LAKE PONTCHARTRAIN, LA. AND VICINITY
LAKE PONTCHARTRAIN BARRIER PLAN
DESIGN MEMORANDUM NO.2-GENERAL DESIGN

SUBJECT: Lake Pontchartrain, Louisiana and Vicinity, Lake Pontchartrain
Barrier Plan, Design Memorandum No. 2 - General, Citrus Back
Levee

COMMENTS ON DESIGN MEMORANDUM NO. 2 - GENERAL DESIGN, CITRUS BACK LEVEE, LAKE PONTCHARTRAIN, LOUISIANA AND VICINITY, INCLOSED WITH LETTER, LMNED-PP, 21 AUGUST 1967, SUBJECT: LAKE PONTCHARTRAIN, LOUISIANA AND VICINITY, LAKE PONTCHARTRAIN BARRIER PLAN, DESIGN MEMORANDUM NO. 2 - GENERAL, CITRUS BACK LEVEE

LEVEE SECTION 1
STA. 176+75.9 TO STA. 195+00 (APPROX.)

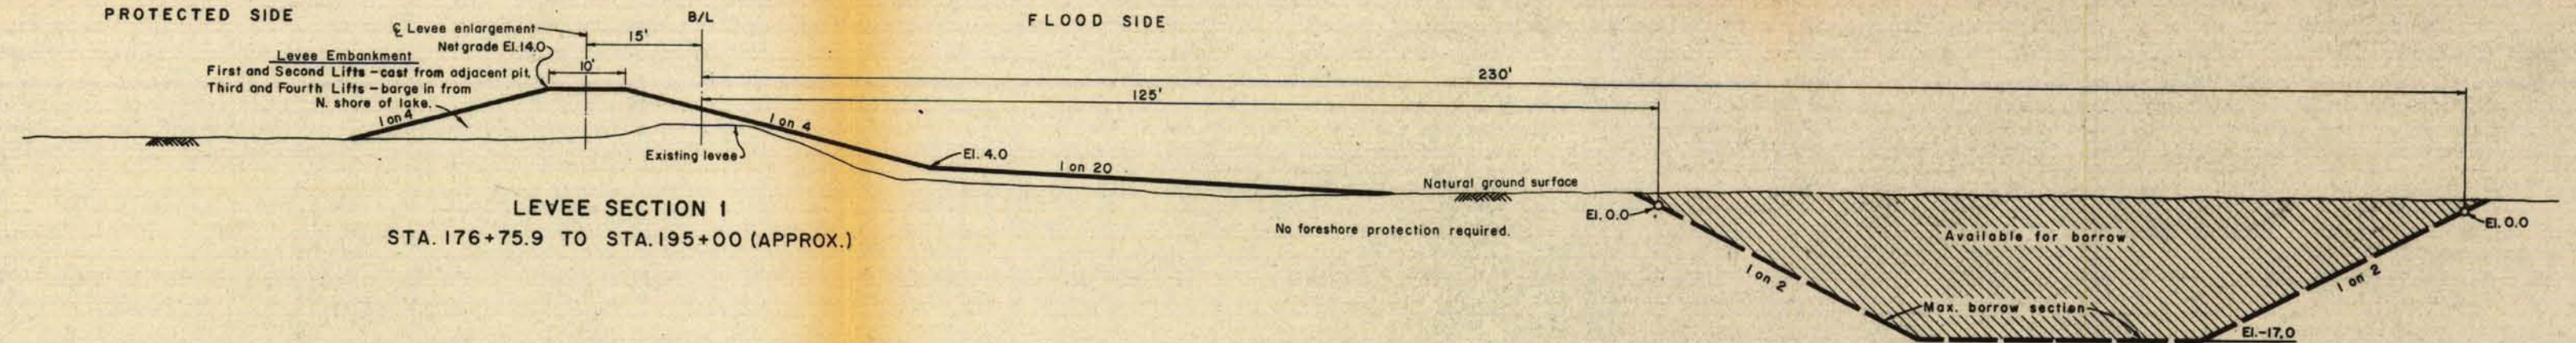
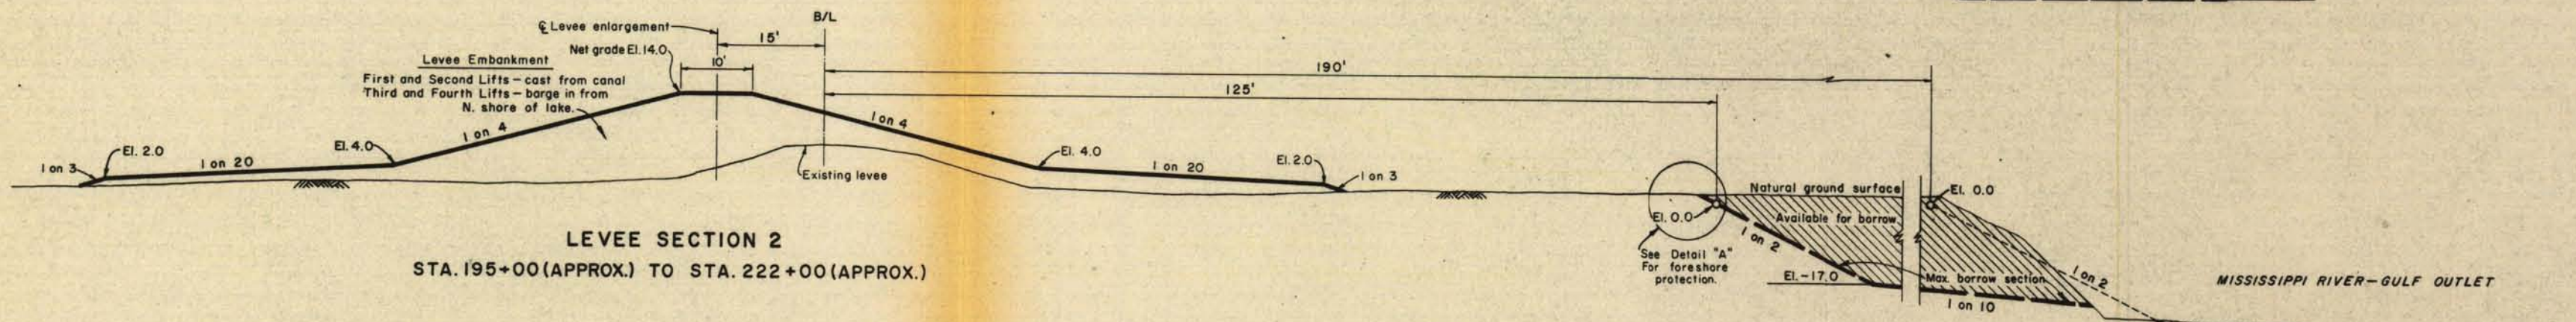
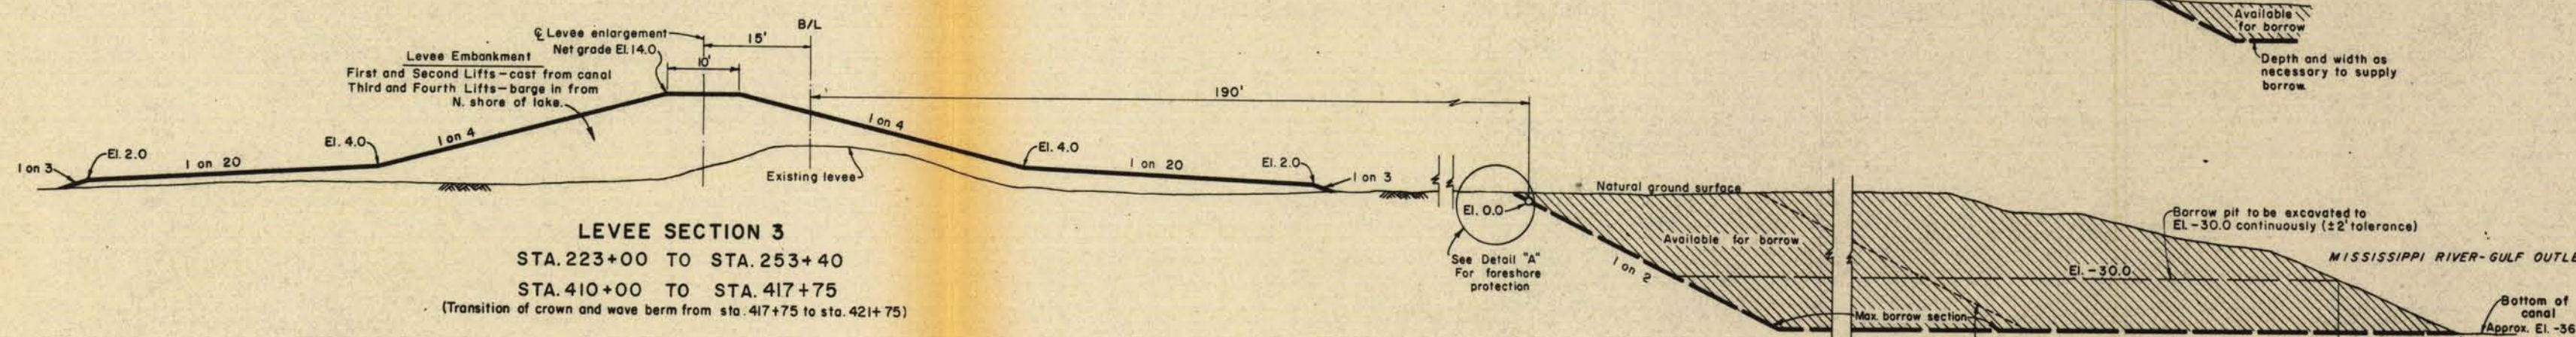
(3) Station 204+00 (approximate) to Station 222+00 (approximate). Existing levee section with protected side groundline at approximate el 0.0, existing borrow pit on flood side, foreshore protection, and available borrow commencing at a distance from the levee enlargement centerline to provide adequate stability. The levee enlargement section and available borrow location will probably be similar to either levee design sections 2 (Plate 6) or 5 (Plate 7).

TYPICAL I WALL SECTION
SCALE: 3/8" = 1'-0"

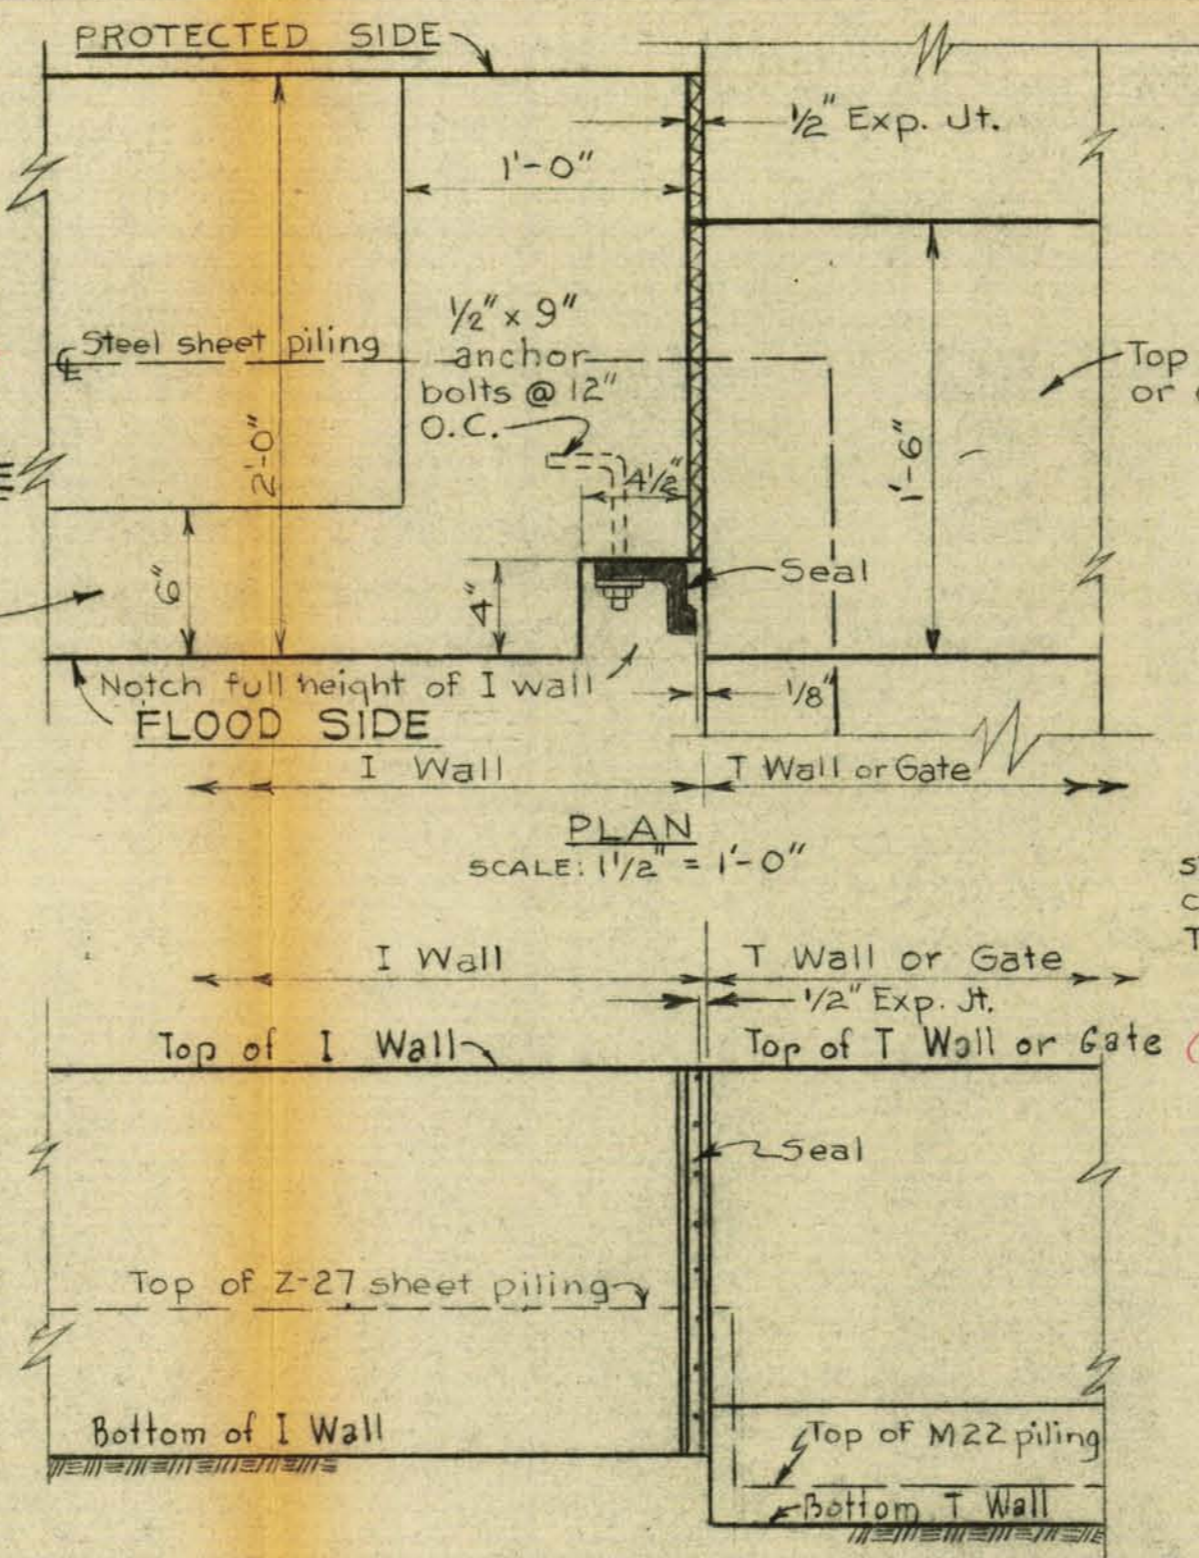
19. Plate 26. a. Typical I-wall section. (1) Rebars passing through the steel sheet piling should be spaced with the piling sections. For example, two bars through each pile section will require one hole in each flange. This will eliminate the need to shift bars in the field to avoid pile webs, or interlocks, and will permit burning, or punching, the holes in the shop. The maximum size hole should be specified to prevent oversize holes.

(2) Except for very low walls, transverse reinforcement (stirrups) should be placed across the wall at the top of the sheet piling. Since tension cracks will, or may, develop at this point, the stirrups should be designed to take the total shear. This is based on the assumption that the crack transmits no shear, thus concentrating the total shear in the compression zone which is outside the piling, and in the absence of transverse reinforcement, will tend to split the concrete.

ELEVATION
SCALE: 1/4" = 1'-0"
TYPICAL JOINT BETWEEN I WALL & T WALL OR GATE

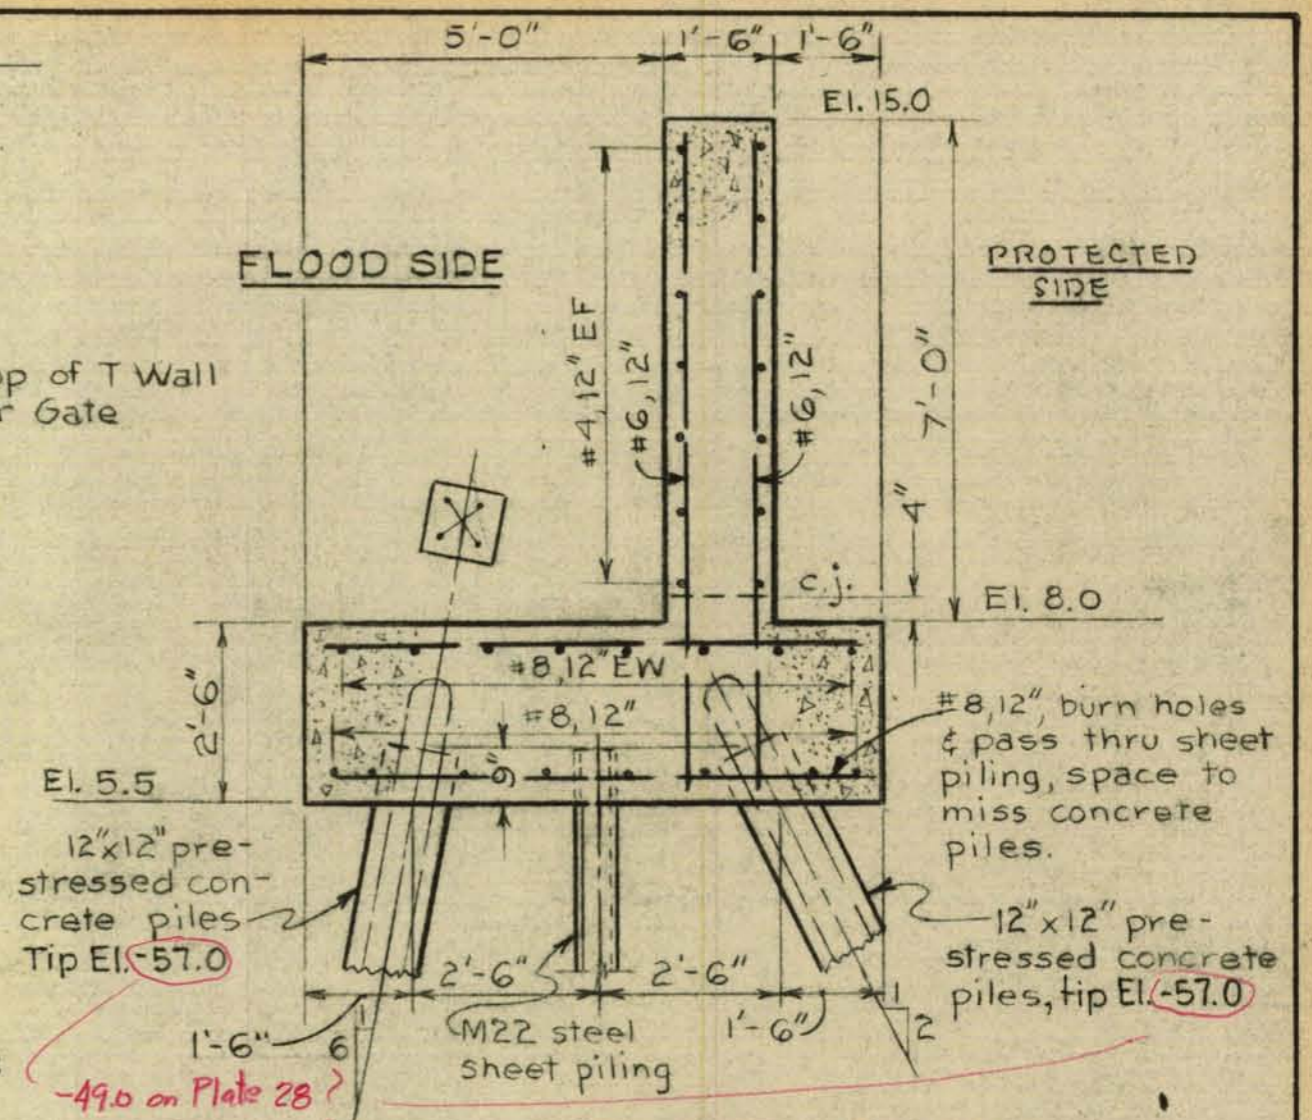
b. Typical Joint Between I-Wall and T-Wall or Gate. (1) The fact that the Z-27 sheet piling under the I-wall extends across the joint and is embedded in the T-wall will cause a transfer of load to the T-wall, and may cause splitting of the concrete. The details of this joint should be studied further.
